Project	IEEE 802.16 Broadband Wireless Access Working Group < http://ieee802.org/16 >	
Title	Enhanced Paging with Assigned Ranging Code	
Date Submitted	2004-06-25	
Source(s)	Hang Zhang, Mo-Han Fong, Peiyong Zhu, Wen Tong	mhfong@nortelnetworks.com
	Nortel Networks 3500 Carling Avenue, Ottawa Ontario, Canada K2H 8E9	Voice: +1-613-765-8983 Fax: +1-613-765-6717
Re:	IEEE P802.16e/D3-2004	
Abstract	This contribution proposes enhanced paging by assigning a ranging code	
Purpose	Review and Adopt the suggested changes into P802.16e/D3	
Notice	This document has been prepared to assist IEEE 802.16. It is offered as a basis for discussion and is not binding on the contributing individual(s) or organization(s). The material in this document is subject to change in form and content after further study. The contributor(s) reserve(s) the right to add, amend or withdraw material contained herein.	
Release	The contributor grants a free, irrevocable license to the IEEE to incorporate material contained in this contribution, and any modifications thereof, in the creation of an IEEE Standards publication; to copyright in the IEEE's name any IEEE Standards publication even though it may include portions

Fig. 2. The proposed solution.

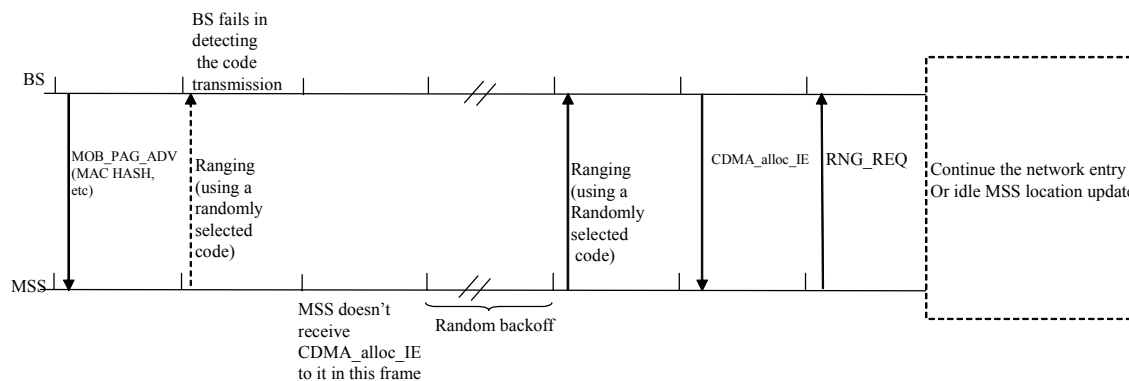
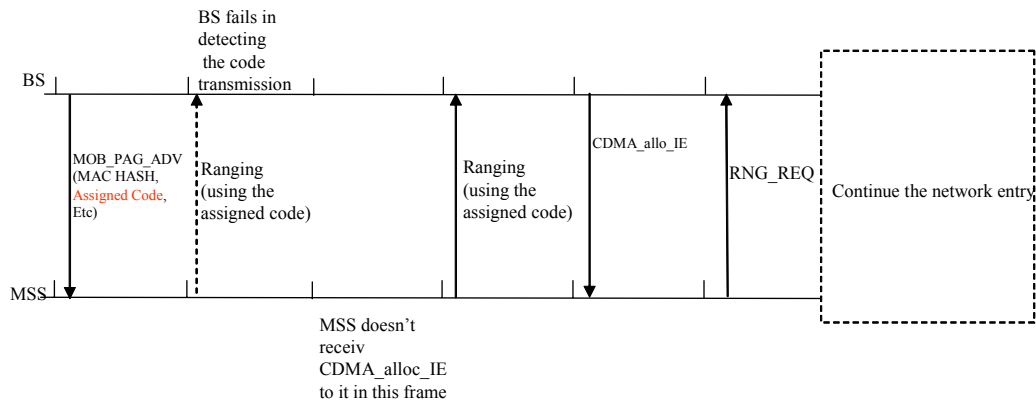
In current paging procedure, after a MSS receives MOB_PAG_ADV message with its MAC hash included, the MSS will perform normal OFDMA based ranging operation. A back-off is required for collision resolution if a MSS doesn't receive an expected CDMA_alloc_IE with resource assignment.

By implementing the proposed enhancement, the paging/response procedure can be accelerated since the delay caused by random back-off can be completely avoided. At the same time, by using the assigned code, possibility of causing collision to other MSSs who are performing ranging will be reduced.

- Each BS reserves a small amount of codes based on the loading situation
- When a BS pages a MSS, optionally, a dedicated code may be assigned to the MSS in the MOB-PAG_ADV message
- The MSS, after receives the paging, shall use the assigned code to perform ranging until the MSS receives the CDMA_alloc_IE to obtain a dedicated resource to send RNG_REQ
